modified type plans for adoption to build
lock-ups in connection with the
construction of a new lockup building at
Sagar.

Modified type plan for adoption to build lockup in connection with the Construction of a new lockup building at Sagar

Type design for Taluk Lock-ups in the State.

— MODIFIED TYPE DESIGN —

— PLAN OF KITCHEN —
MUD WALL TO BE
PUT UP BY
CONVICTS.
8'x8'

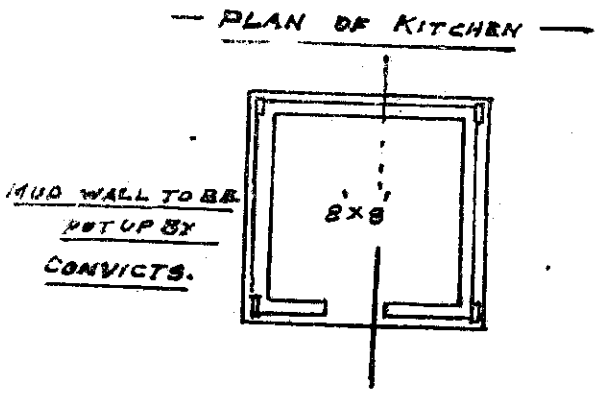
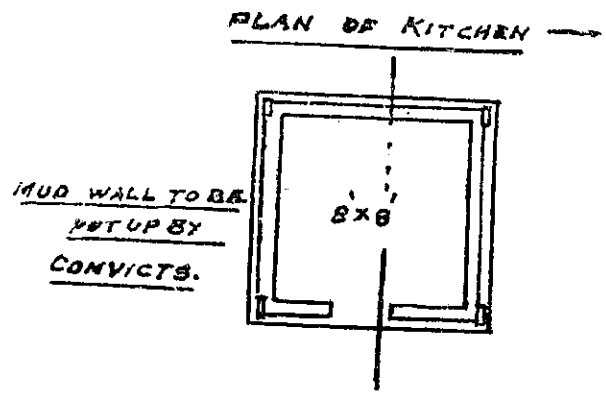
3) In respect of the kitchen, mud walls to the partitions by Guards has been proposed. The Dy. Commr. in his Remark in Para 4 of his report has brought to the notice of the Govt. the unsuitability of the kitchen unpartitioned by pucka walls & doors &c. Before adopting the plan, it may perhaps be desirable to obtain plans of Sub-Jails in the Bo. India - adopted on the recommendations of the Bo. Jail Committee, and detailed information on the above points obtained.

4) The plan may perhaps be approved as a pattern for Taluk Lock-ups. The kitchen is proposed to be built of mud-walls by the convicts themselves. This is open to objection raised by the Dy Insp Genl on previous occasions, that mud-walls are unsatisfactory & unsafe. It be desirable to obtain model plans from B before finally adopting the pattern.
